Docket Item # 13
BAR CASE #2008-0189

BAR Meeting
November 5, 2008

ISSUE: Signage
APPLICANT: The Sign Shop
LOCATION: 728 Jefferson Street
ZONE: CRMU/L, Commercial

Figure 3: Jefferson Street sign detail

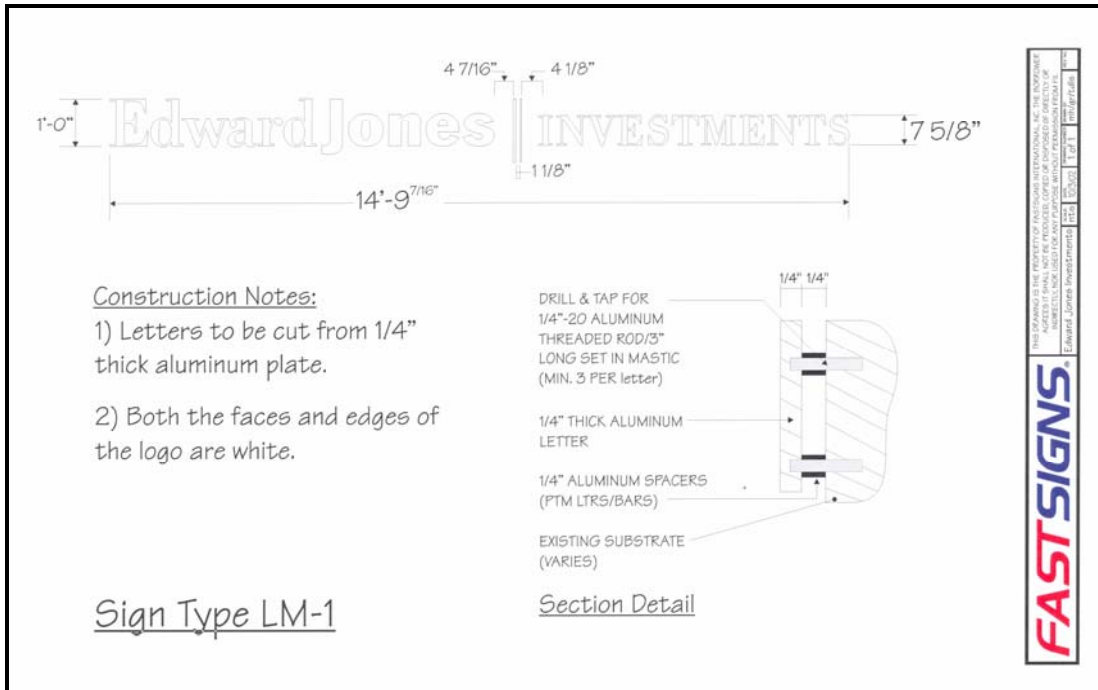
The *Design Guidelines* generally recommend that only one sign per business is appropriate. However, given that this is a corner business with two street frontages and that the signs will not be illuminated, Staff recommends approval of signage on both elevations. The *Guidelines* also state that "On masonry buildings, signs should be anchored through the mortar joints rather than directly into the masonry unit (e.g. brick) itself. Therefore, Staff recommends approval of the application with the condition that the wall signs be anchored into the mortar joints and not into the brick.

C-1 Wall letters / signs must comply with USBC [H103-H111] Please indicate the method to be used for anchoring the letters to the wall.

IV. STAFF RECOMMENDATION: Staff recommends approval of the application with the condition that the signs be anchored into the mortar joints and not into the brick.
